## TP-LINK CORPORATION PTE.LTD.

Subject: Requesting Class II permissive change for FCC ID: 2BCGWEAP610GPDT

The purpose of this letter is to request a Class II Permissive change for FCC ID: 2BCGWEAP610GPDT, original granted on 05/09/2024.

schematic diagram:

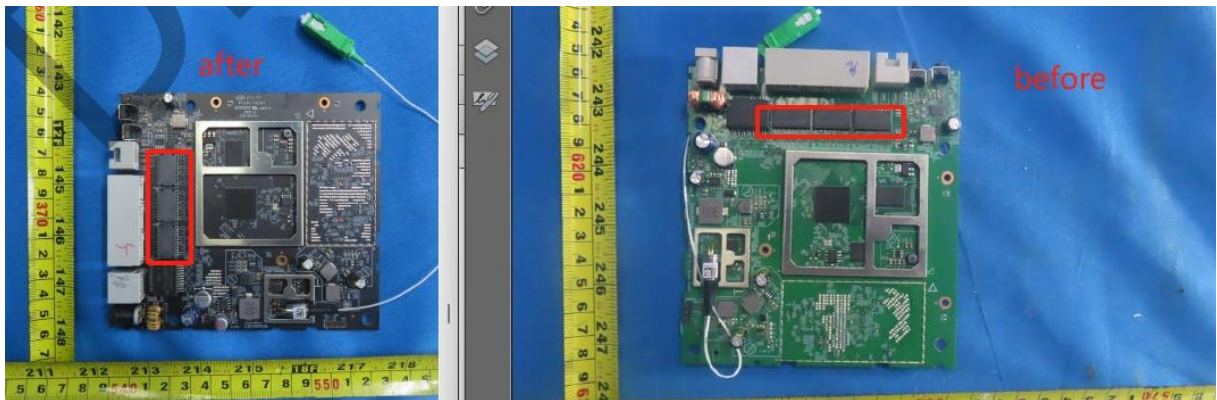
1. Change the signal transformer of the network port. (Update transformer model number.)

Page 13: T2 T3 T4: SG24301 replaced with HST-24022SXCR.
